114.8 Medium Dependent Interface (MDI)

114.8.1 MDI mechanical interface for 1000BASE-RHA

Figure 2: a) Duplex POF cable splitting, b) 1000BASE-H MDI receptacle to POF cable connection

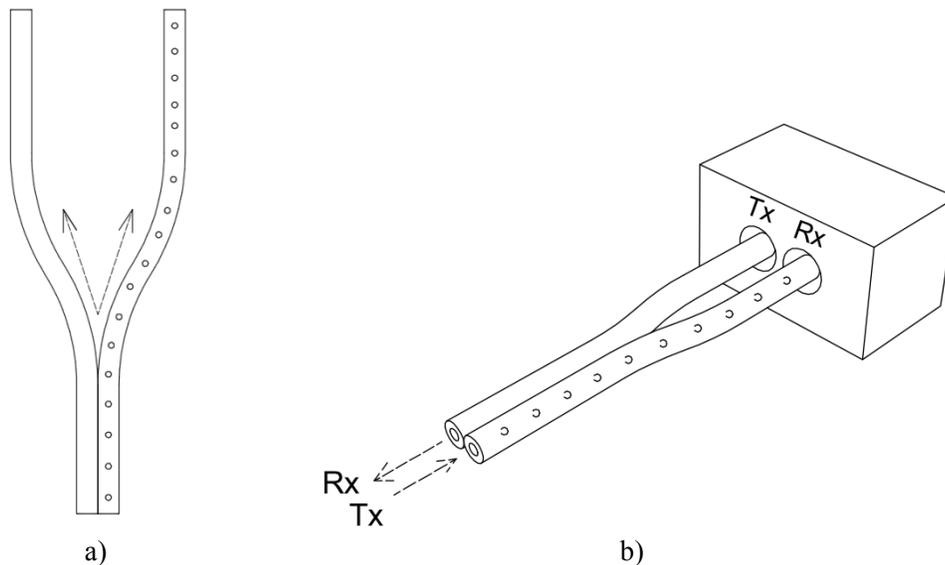
Is a specific value necessary? How about just say "a bend radius large enough."
and let the ISO specify the value?
